**Overview:** Production error; immobilizer wire (orange/black) in pin position #4 instead of pin position #5. Although an effort to correct the issue was made, some quantity of harnesses did get shipped before the issue was spotted. We are advising to inspect the harness BLADE connector before attempting to install the harness and program the module.

Make	Model	Year	Install	CECU/KAECU	Lights	ECU	POC	I/O Changes
<b>DL-SUB2</b>								
Scion	FR-S PTS AT	2013-16	Type 1	BGB	Park / Auto DATA	BGB	N/A	Green White/Blue NONE/NONE

## FTI-STP1: Notas de instalación y configuración

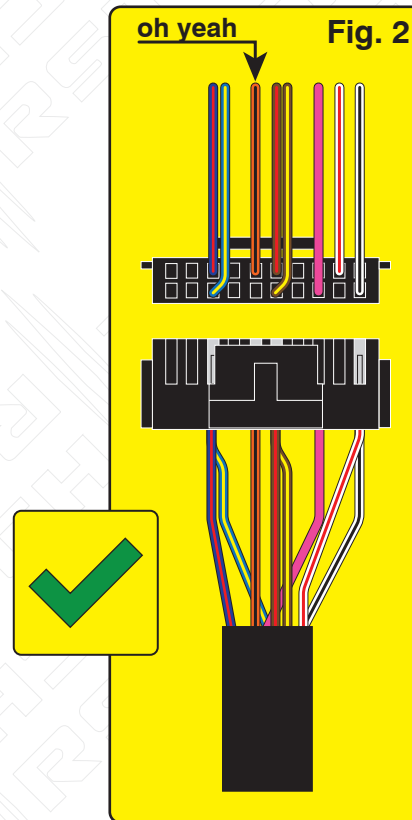
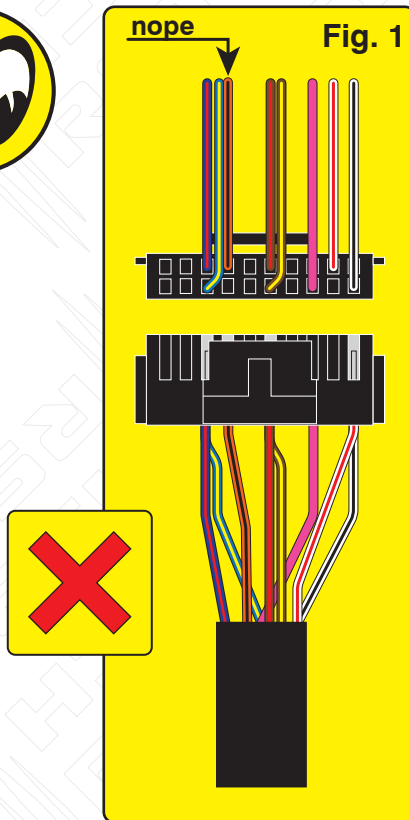
**Issue:** Module fails to program to vehicle, will not allow the vehicle to be remote started.

**Correction:** Step 1.) Locate the orange/black wire and confirm whether it is positioned as illustrated in Fig. 1 or Fig. 2. If the wire is as illustrated in Fig.1, proceed with Step 2 through 5 and complete the repair procedure outlined, if the wire is as illustrated in Fig. 2, correction is not necessary, proceed with harness installation and module programming.

**Step 2.)** Using a pick, lightly depress the catch that secures the terminal in the housing then remove the wire and terminal from the housing.

**Step 3.)** Using a fine tip razor or utility knife, insert the blade beneath the terminal catch and raise it slightly, so that it can be reused to secure the terminal when reinserted into the BLADE connector housing.

**Step 4.)** Refer to Fig. 2 for correct position of the orange/black wire (next to brown/red) then reinsert the terminal, pressing lightly until the catch 'snaps' into place, securing the terminal in the connector housing.

**MODIFICACIÓN REQUERIDA PARA APLICACIONES DE TRANSMISIÓN AUTOMÁTICA ÚNICAMENTE**

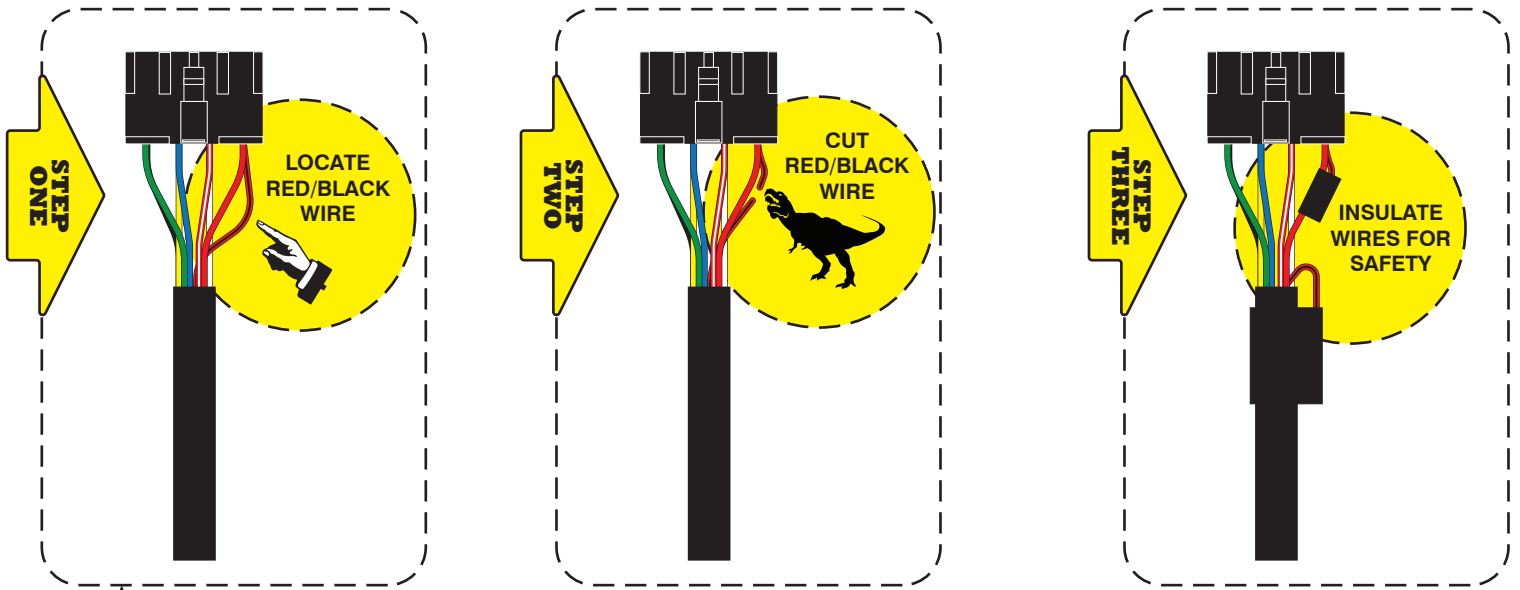
**Problema:** El arnés en T FTI-STP1 ha sido diseñado para ser compatible con AT (transmisión automática) y MT (transmisión manual), pero debido a una supervisión de la producción, el mecanismo de selección se estableció por defecto en el modo MT.

*El uso de un arnés configurado para una aplicación MT, en un vehículo equipado con AT, podría provocar daños en el módulo del vehículo. Se recomienda que el arnés vuelva al modo AT antes de instalarlo en vehículos equipados con transmisión automática.*

**Corrección:** Localice el cable rojo/negro (+ embrague) provisto en el conector CN1 del conjunto del arnés principal. Corte el cable rojo / negro, ya sea al ras del conector CN1 o dejando suficiente cable expuesto para que pueda aislar y asegure los extremos del alambre que quedan después del corte. Aísle cada uno de los extremos restantes del cable rojo/negro y asegúrelos para evitar cualquier posibilidad de cortocircuito.
